A585 Windy Harbour to Skippool Improvement Scheme

7.11 Environmental Statement Changes and Corrections Document

Environmental Statement Changes and Corrections Document

Version	Date	Status of Version
Rev 0	May 2019	Deadline 2 Submission
Rev 1	July 2019	Deadline 4 Submission

APPENDIX D – Updated Figure 11.1: Noise and Vibration – Noise Monitoring within the Study Area and Figure 11.4: Noise and Vibration – Noise Mitigation

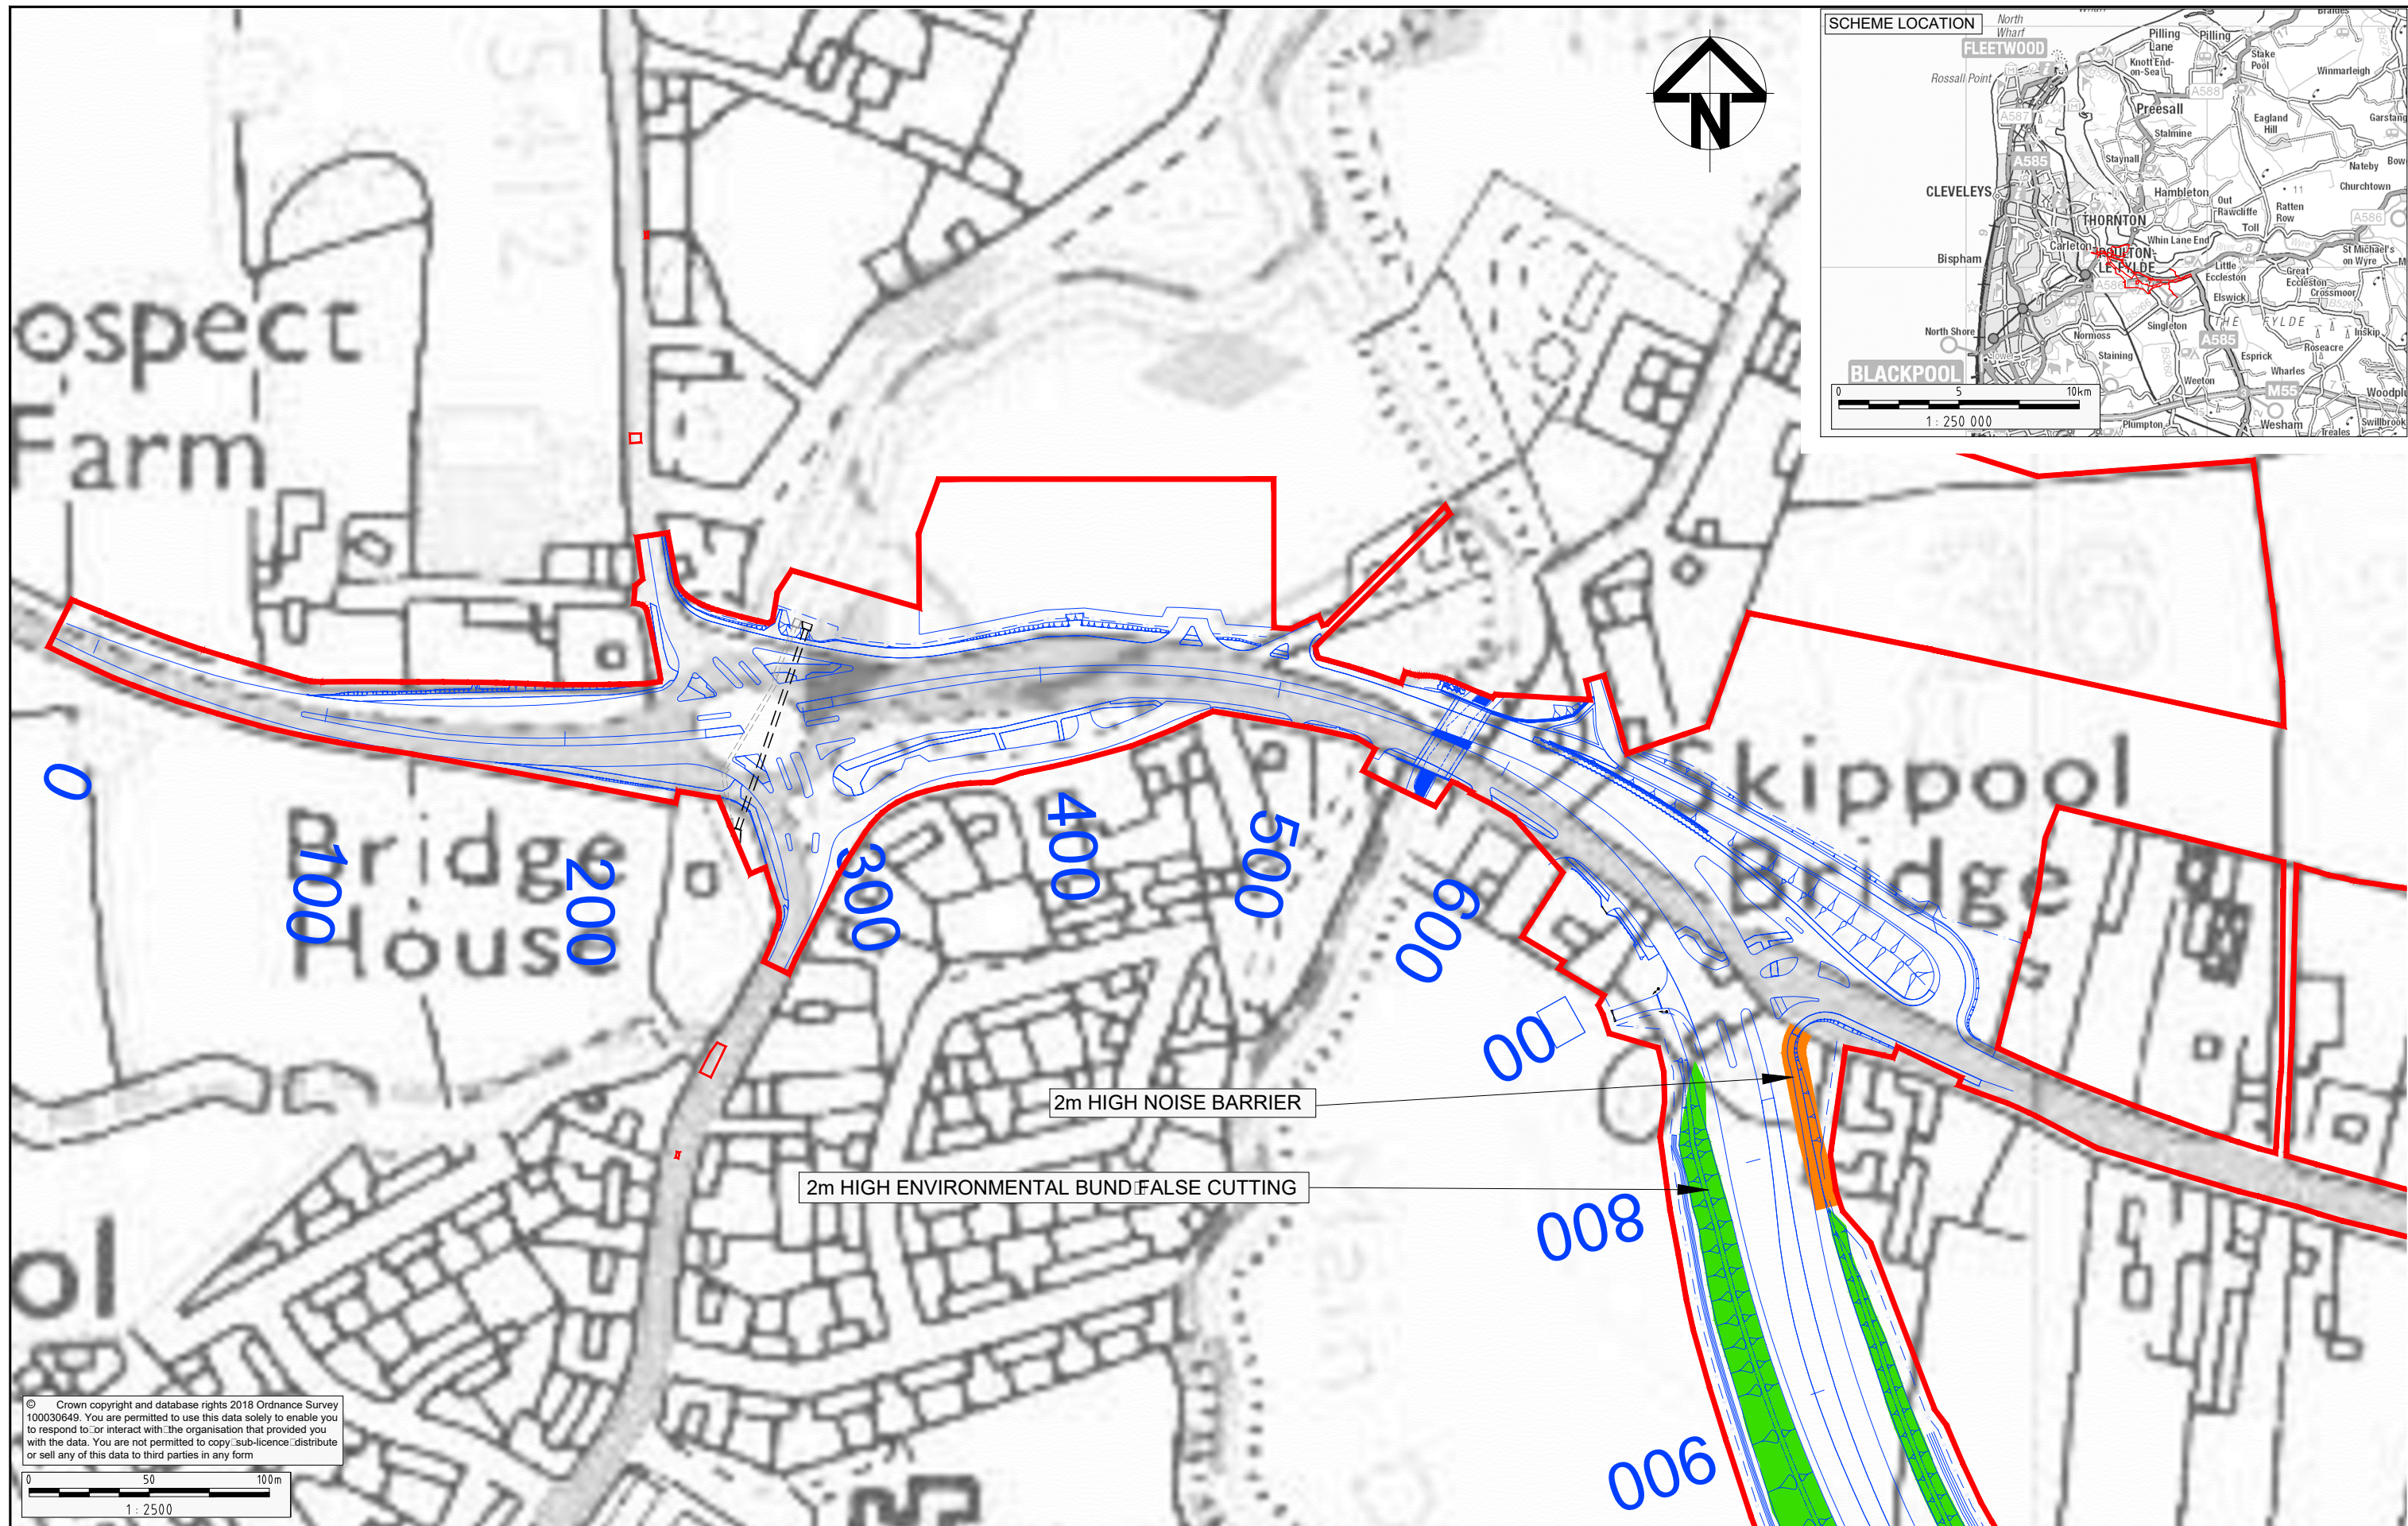
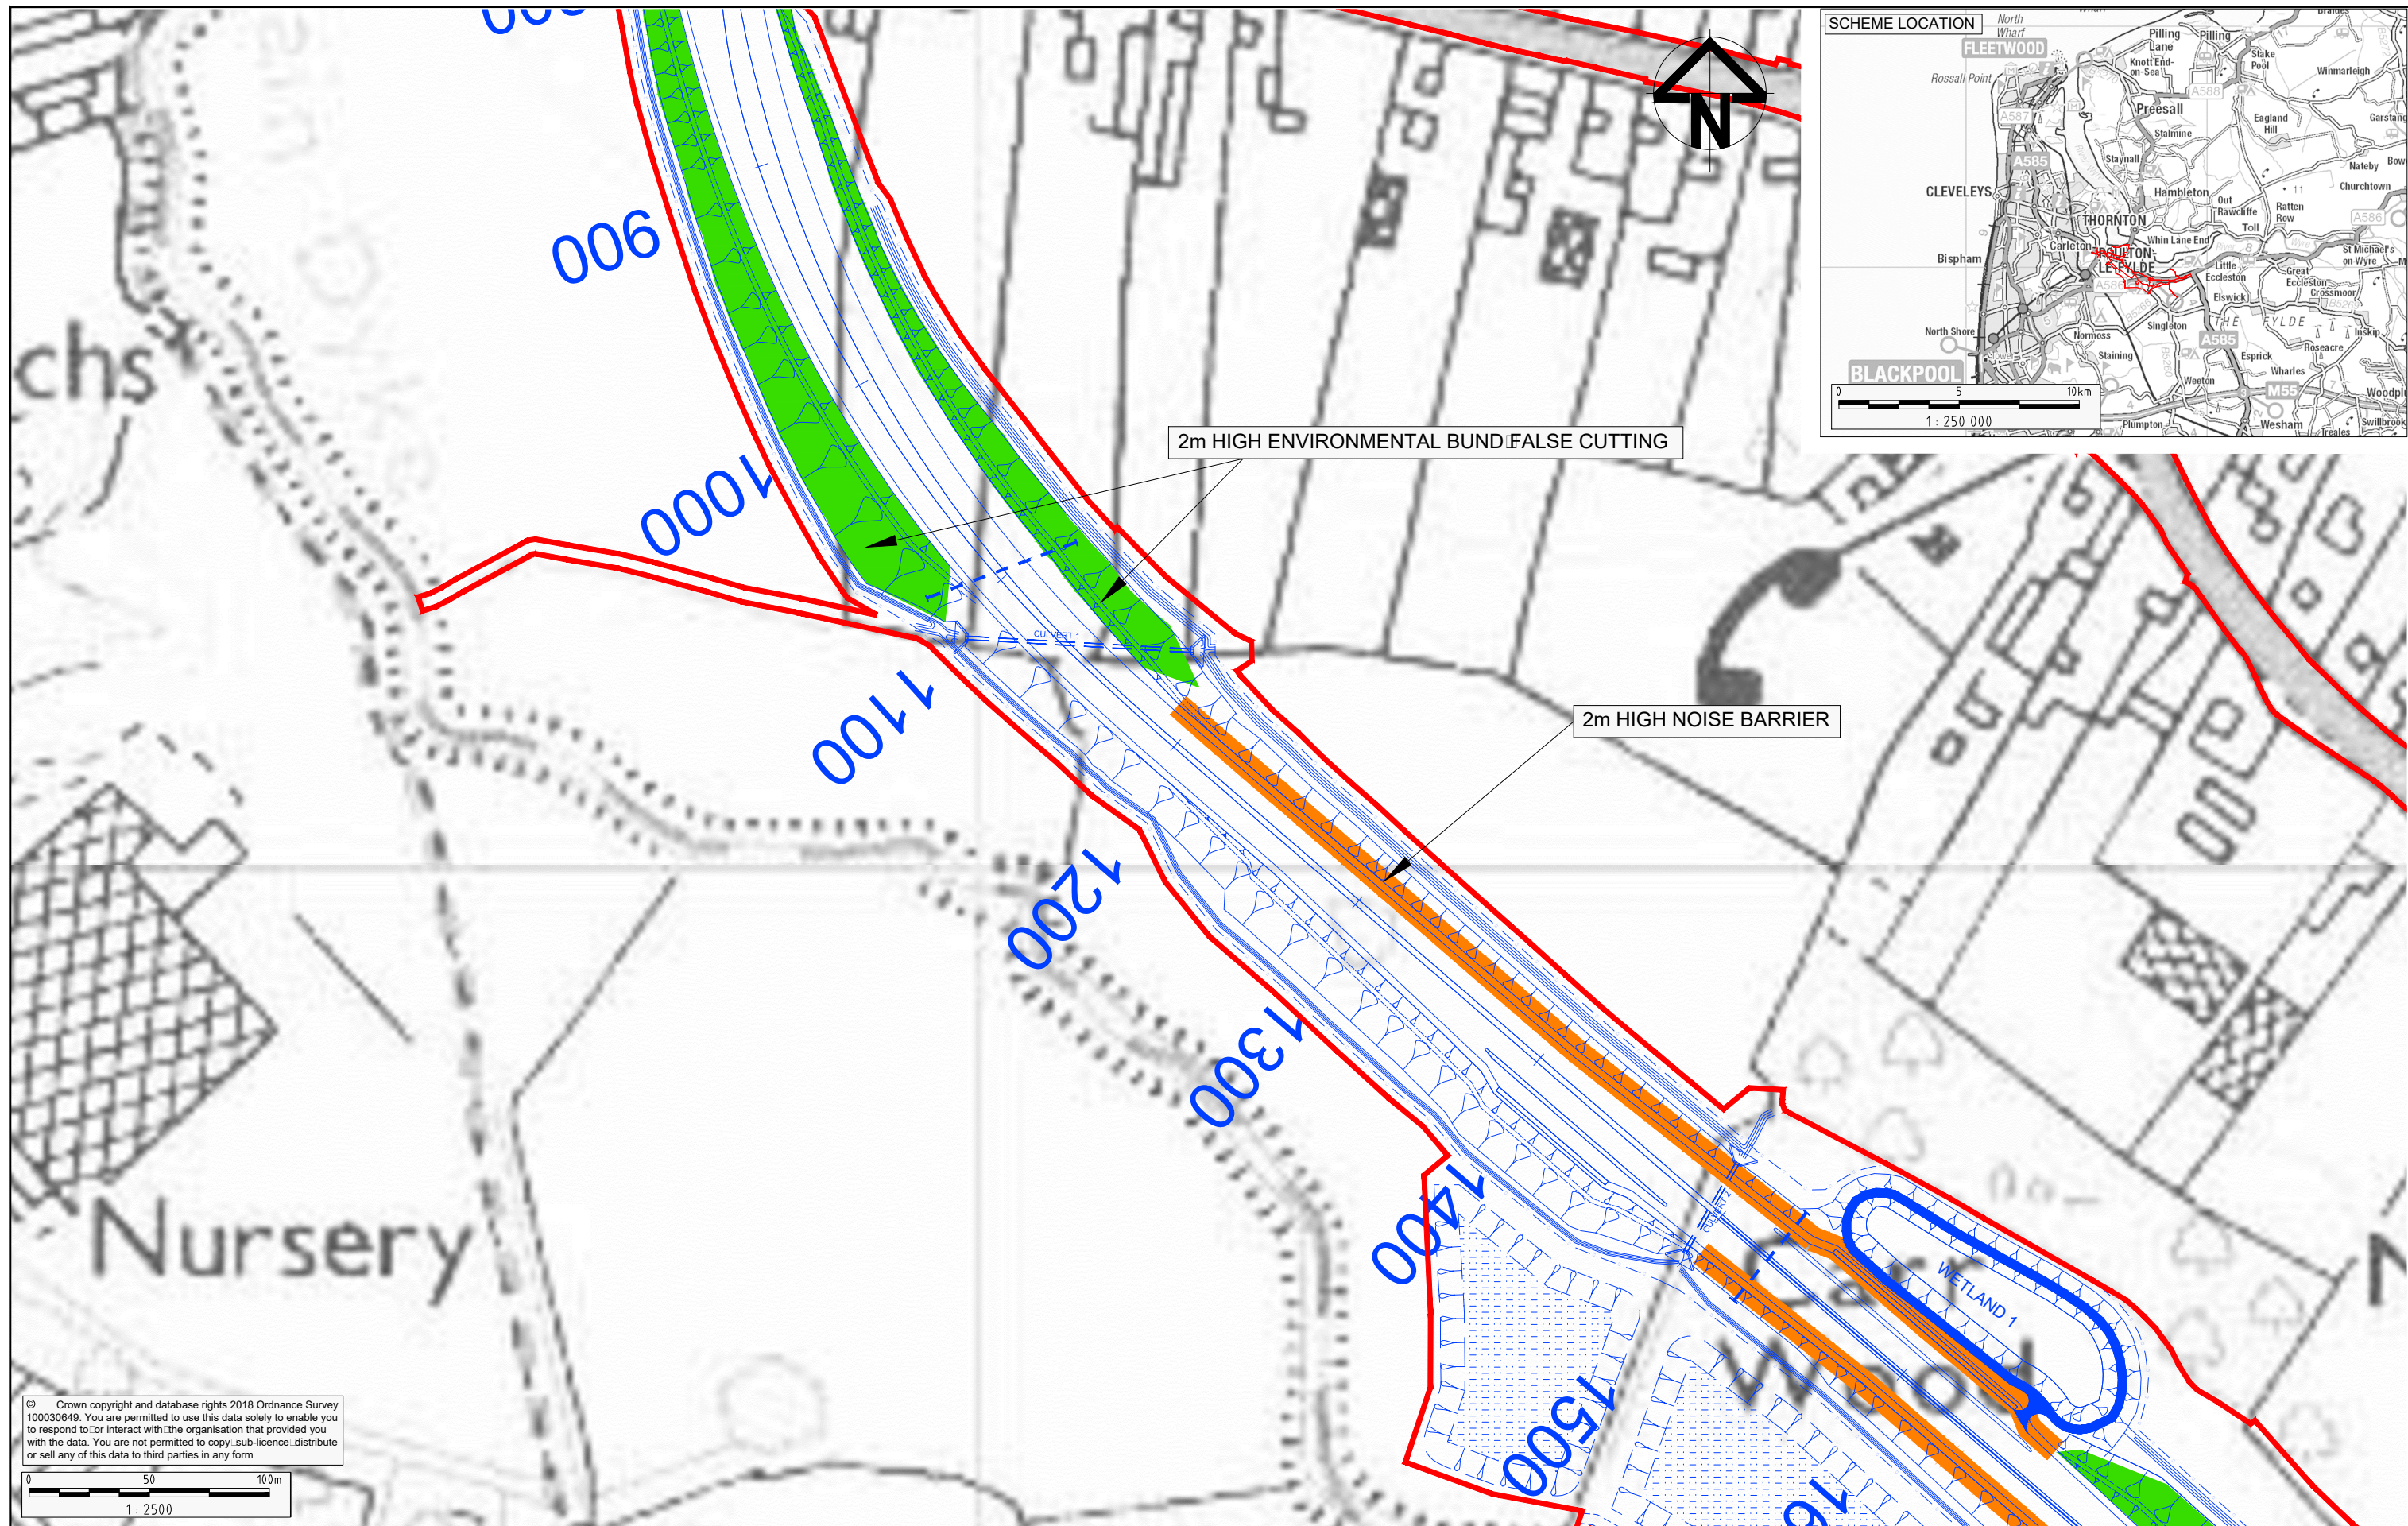
Document Reference Number	Document Name	Amendment Required	Reason
			TR010035/APP/7.10).
6.11	ES Chapter 11: Noise and Vibration	Update to Figure 11.4: Noise and Vibration – Noise Mitigation within the Study Area presented at Appendix D to show heights and locations of earth mounds and acoustic fencing at a larger scale.	Requested by the Inspector within the first round of written questions (document reference TR010035/APP/7.10).
